## STAFF RECOMMENDATION

0 Plymouth Ave  
May 20, 2020

**Application:** New Construction - Infill  
**District:** Eastdale Place Neighborhood Conservation Zoning Overlay  
**Council District:** 7  
**Base Zoning:** RS-10  
**Map and Parcel Number:** 061120091.00  
**Applicant:** Jon Duke  
**Project Lead:** Jenny Warren, jenny.warren@nashville.gov

**Description of Project:** Application for new construction of a single-family house on a vacant lot.

**SITE PLAN FOR  
BRIXTON HOLDINGS, LLC**  
PLYMOUTH AVENUE  
INSTRUMENT# 20191125 PAGE 121387  
7th COUNCILMANIC DISTRICT OF DAVIDSON  
COUNTY,  
METROPOLITAN NASHVILLE, TENNESSEE  
PROPERTY MAP 61-12 PARCEL 91  
DATE MAY 1, 2020 0.24 ACRES  
JOB # 5718  
SCALE 1"=20'

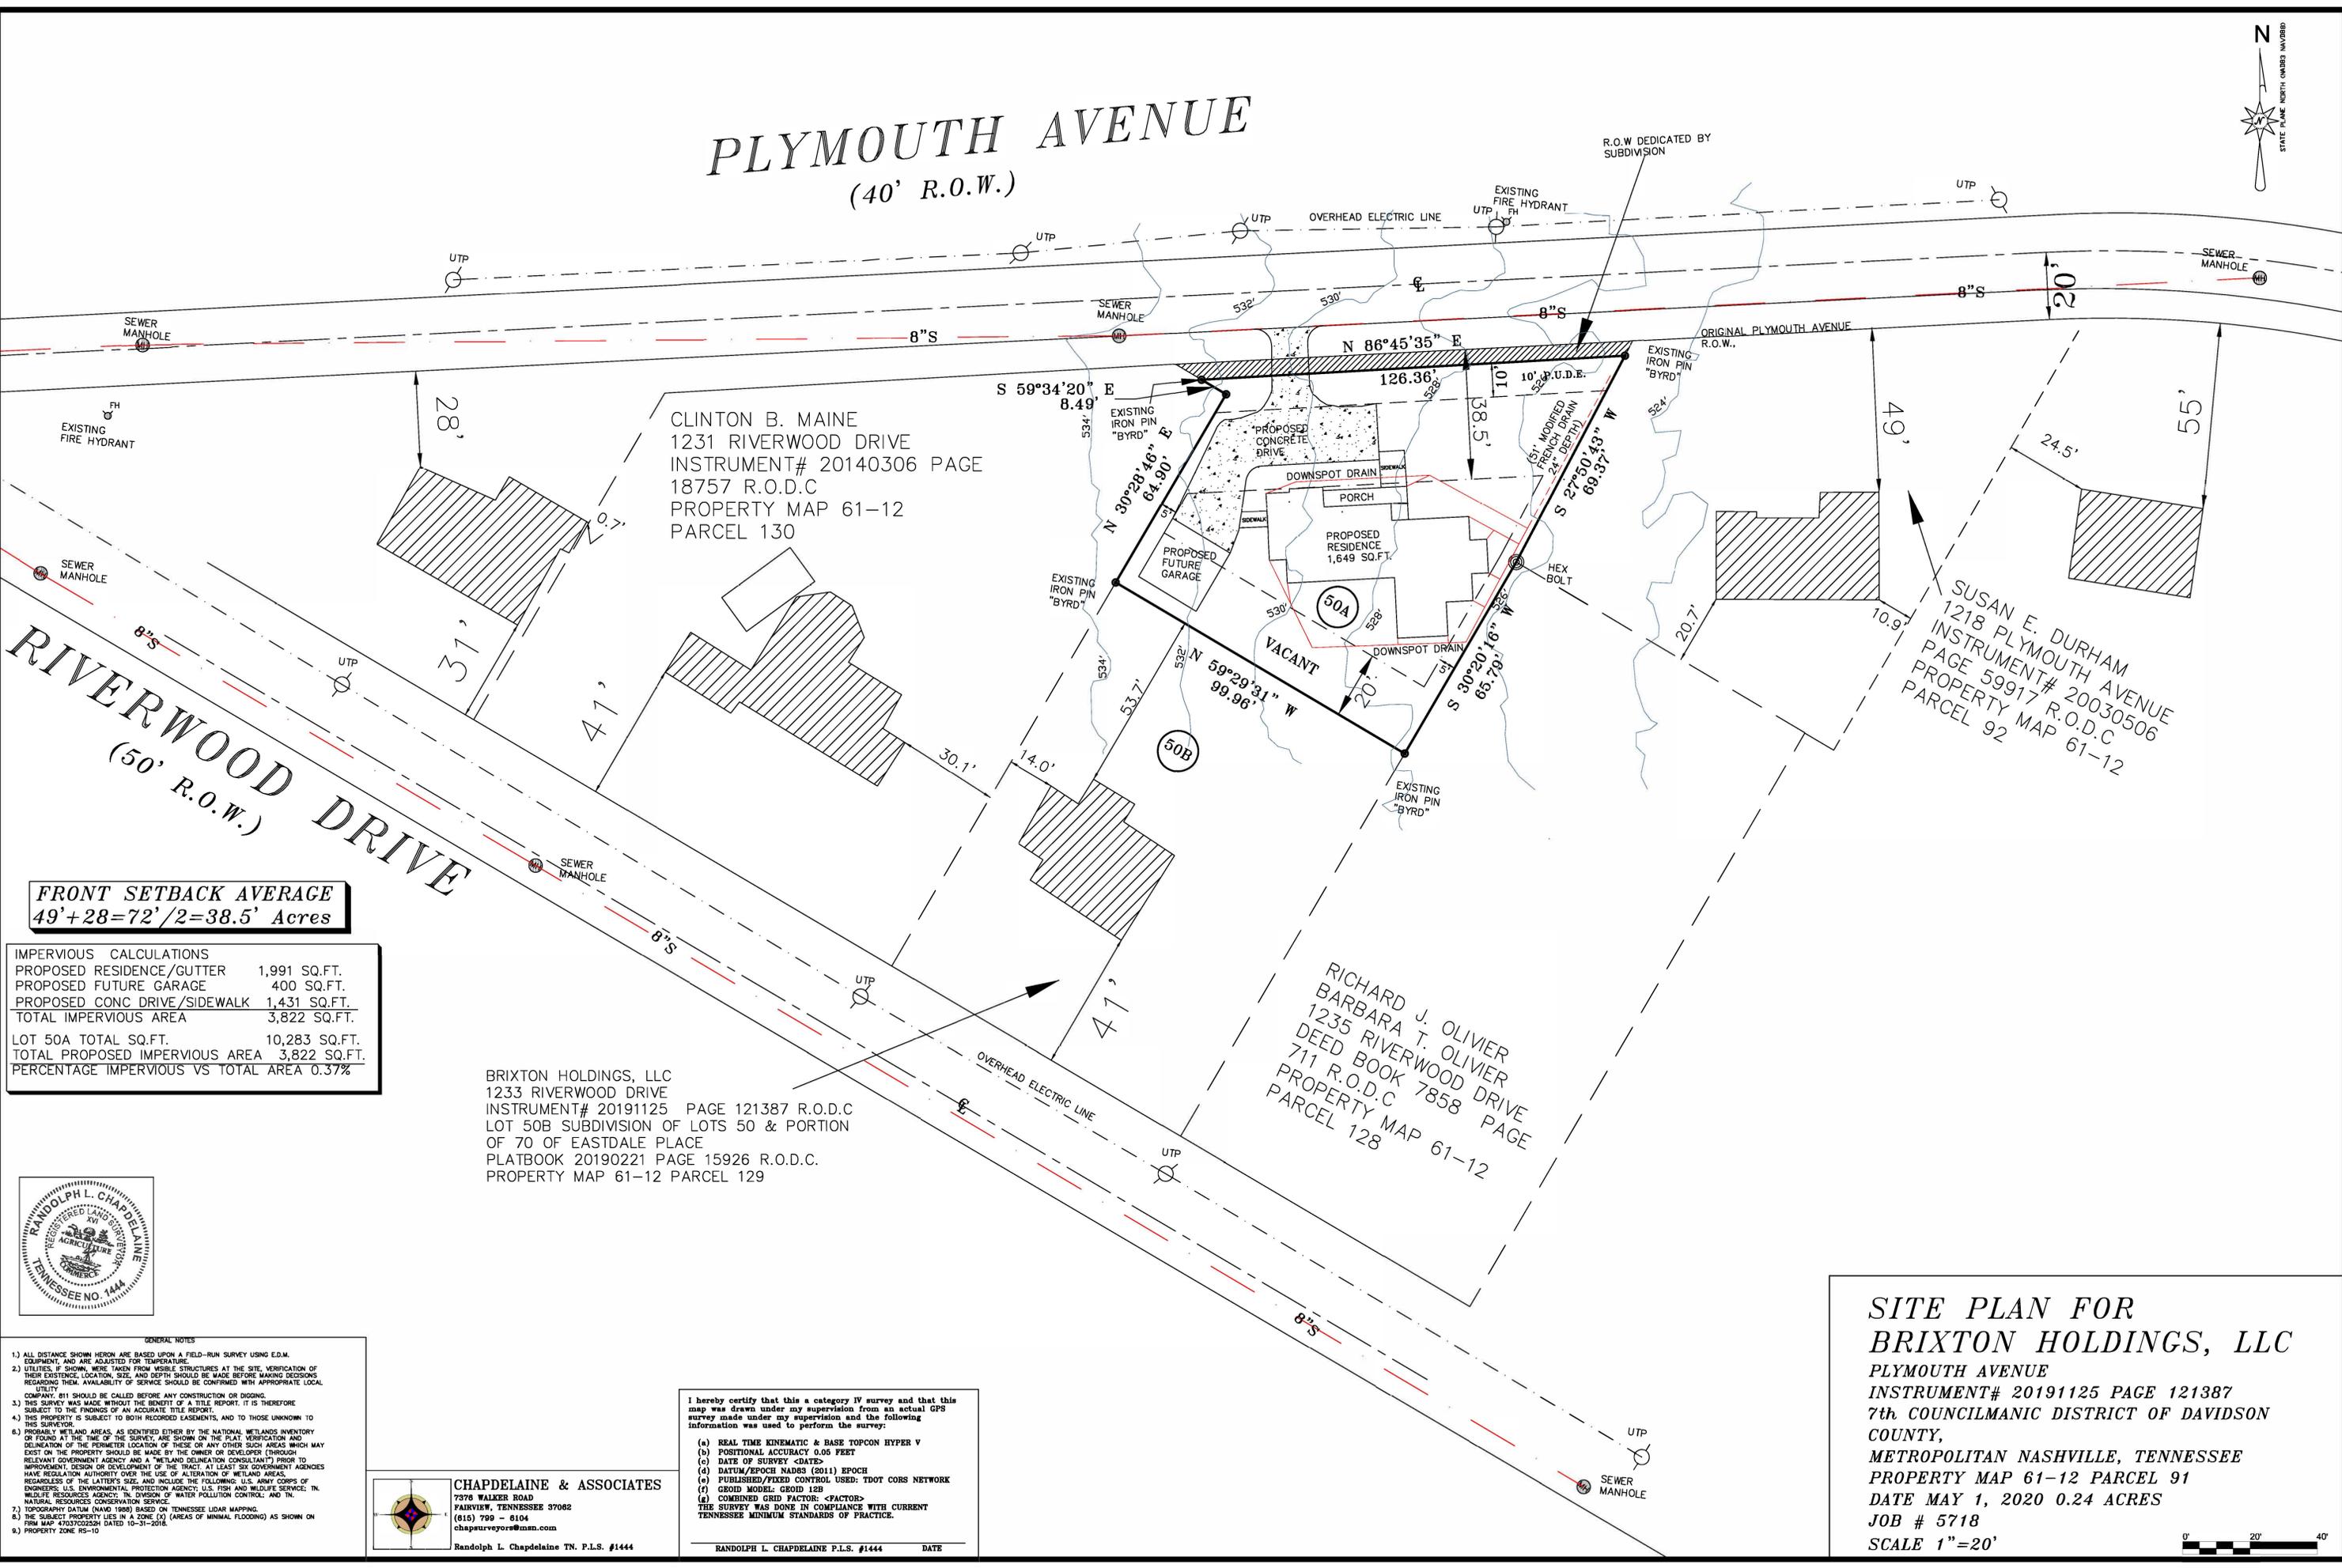
The applicant is proposing a front setback of about thirty-eight feet, six inches (38'6"). This is roughly halfway between the setbacks of the flanking historic properties: 1200 Plymouth has a front setback of twenty-eight feet (28') and 1218 Plymouth has a setback of forty-nine feet (49').

Outbuilding: No outbuilding is proposed at this time, however, there will be a driveway leading to the location of a proposed future garage. The site plan indicates a single curb cut with the driveway leading to the side of the house. The driveway should be no more than twelve feet (12') wide. The outbuilding location was not reviewed.

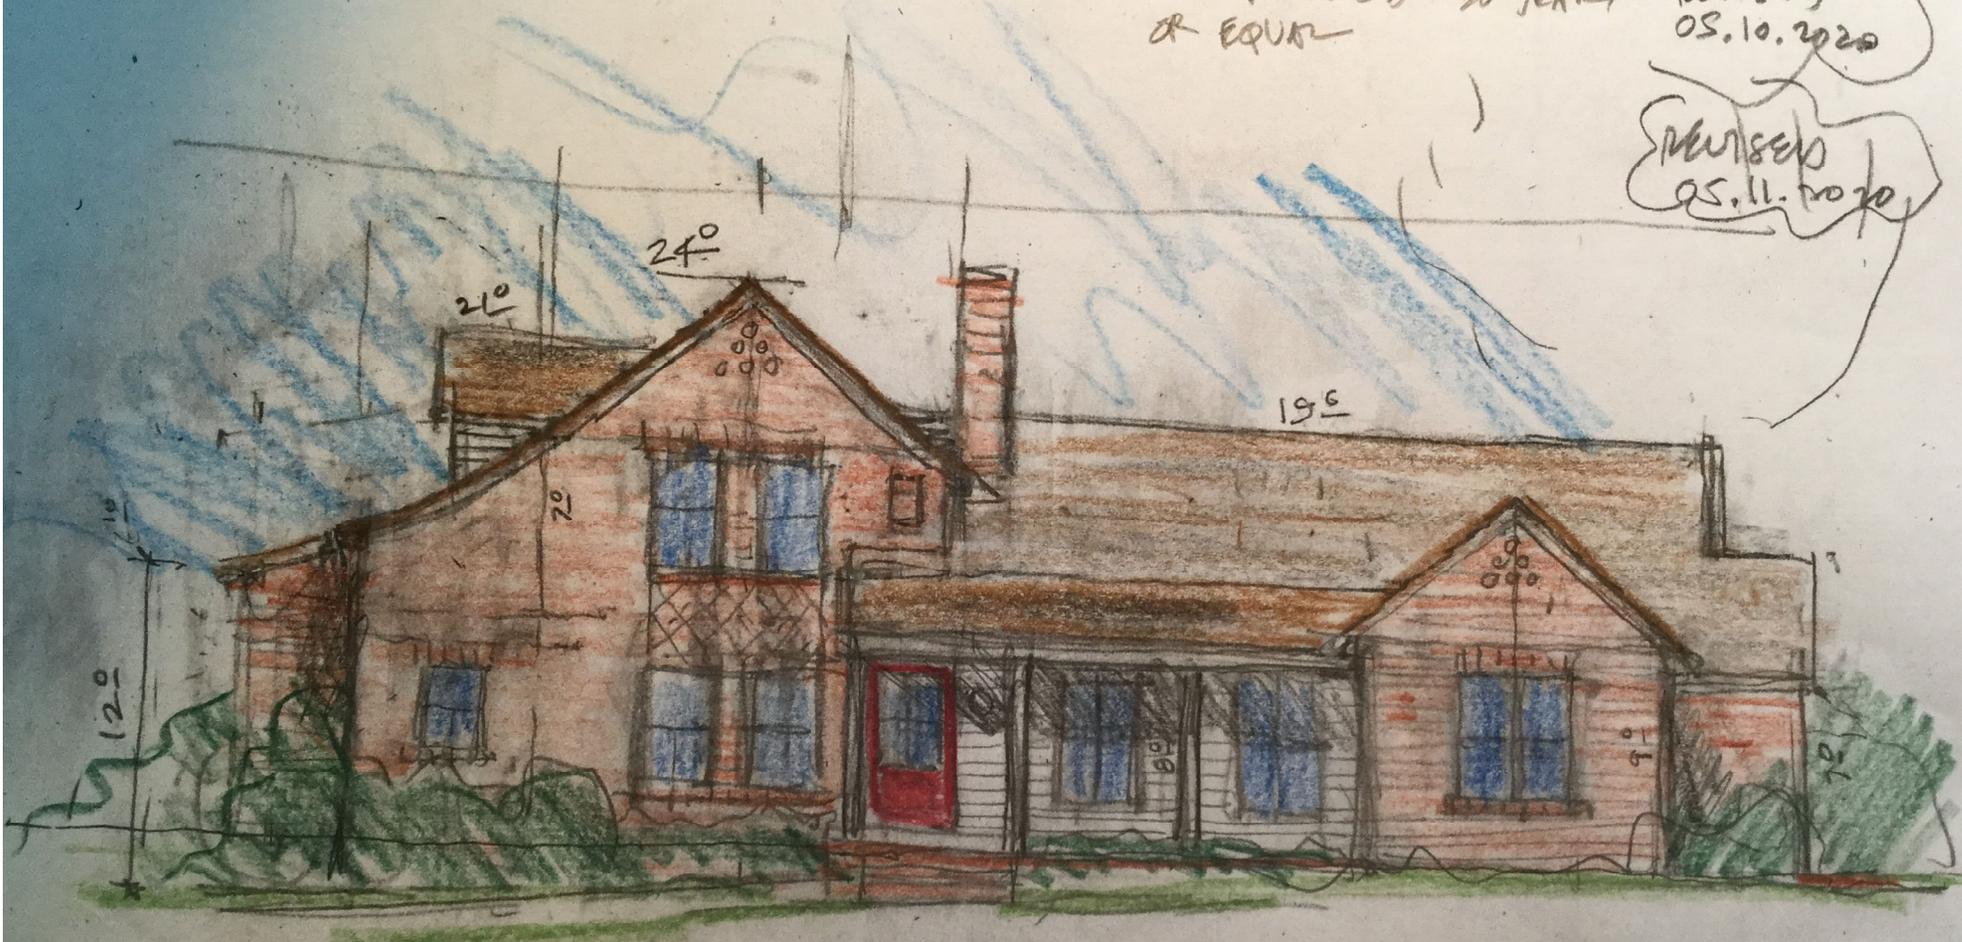
The houses in the immediate historic context are mostly one-and-a-half story forms with a few one stories. The average height in the historic context is about seventeen to twenty-four feet (17-24'). The proposed house has a one-and-a-half story form on the front elevation and a maximum height of twenty-four feet (24'); however, the eave height of portions of the home, especially on the right side elevation (Figure 4), are more consistent with a two-story home. Staff finds that the tall eave on the left-front side, above the front door, could be appropriate as a feature that is typical of the style of home and because it does not rise to a full two-story level. However, the right-side and rear-left side eave heights are not consistent with the neighborhood. This is the first infill for this neighborhood since the overlay was created and so could set a precedent for future projects.

With the condition that the side elevation eave heights are lowered to be consistent with a one and one-half story house, staff finds that the project's height and scale meet Sections III.A. and III.B. of the Eastdale Place design guidelines.

1. The side elevation eave heights are lowered to be consistent with a one and one-half story house;
2. The finished floor height shall be consistent with the finished floor heights of the adjacent historic houses, to be verified by MHZC staff in the field;
3. Staff shall approve the final foundation material, brick color, roofing color, trim material, porch post material, porch floor and step material, doors and the driveway material;
4. The curb cut shall be no more than twelve feet (12') wide; and,
5. The HVAC shall be located behind the house or on either side, beyond the midpoint of the house.

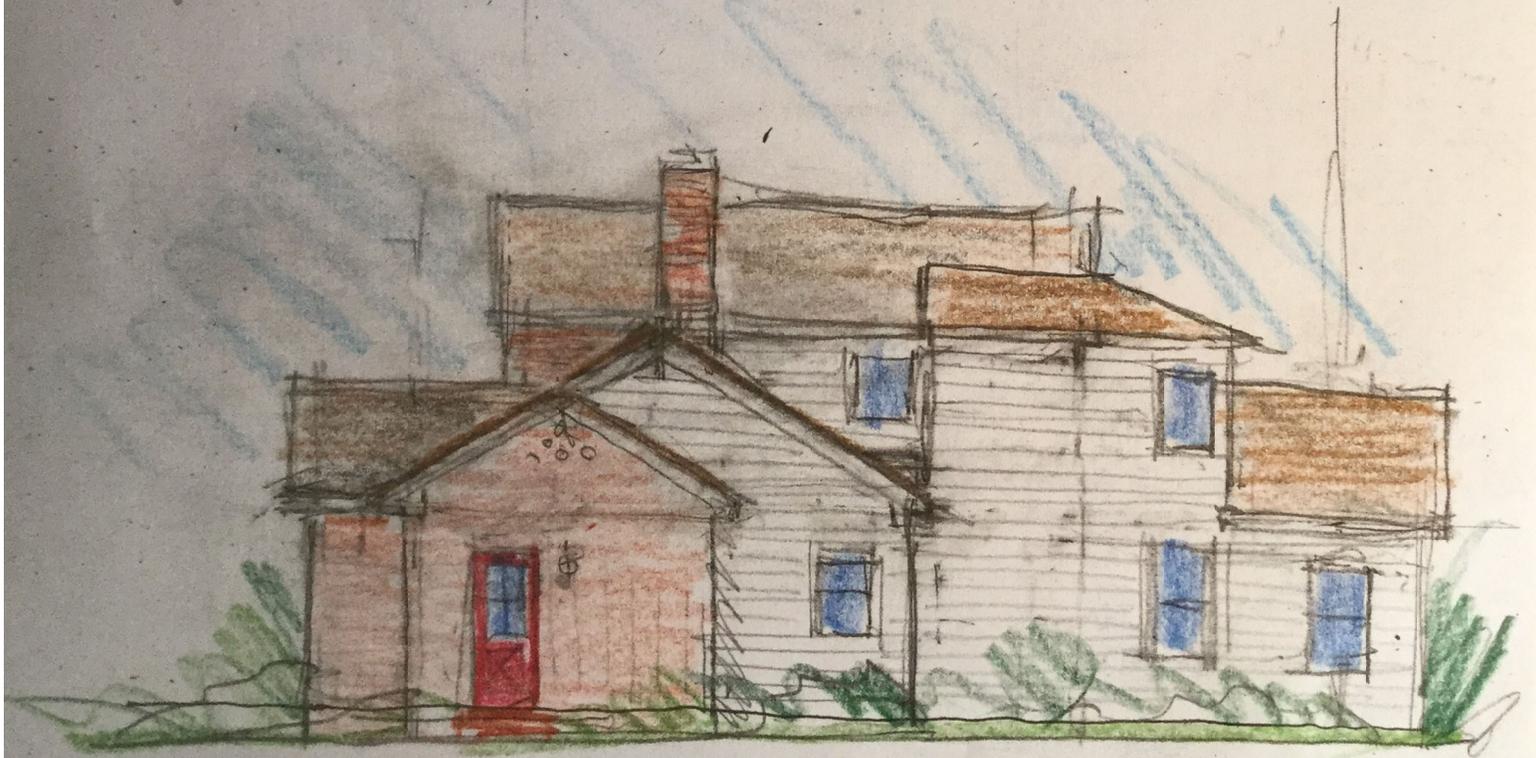
In Eastdale, the houses are primarily brick, with other siding used as an accent material. The applicant proposes to use a cement fiberboard product with a seven inch (7”) reveal as an accent material at the entrance and on the dormer, which is appropriate. However, the sides and rear of the home are primarily lap siding, including the portion of the house with a two-story eave. The lap siding, as proposed, may be appropriate since the portion of the right-side which is not brick is greatly inset (assuming the eave is lowered) and only a small portion of the left side is lap siding. If the rear portion of the home has lowered eaves, the lap sided portions of the home are not likely to be visible from the street.

On the right side elevation, a hipped portion of roof steps out from the primary front-facing gable. The roof projection is not reflected on the front elevation, though it appears that in elevation, it should be visible. This is an atypical roof form but could be appropriate if the eave heights are lowered, lessening its visibility from the street. With the condition that eave heights are lowered to be consistent with a one and one-half story house, the project could meet Section III.E. of the Eastdale Place design guidelines.

With the condition that the rear eaves be lowered to obscure the lap-sided portions and with final staff approval of the foundation material, brick color, roofing color, trim material, porch post material, porch floor and step material, doors and the driveway material, staff finds that the project’s materials meet Section III.D. of the Eastdale Place design guidelines.
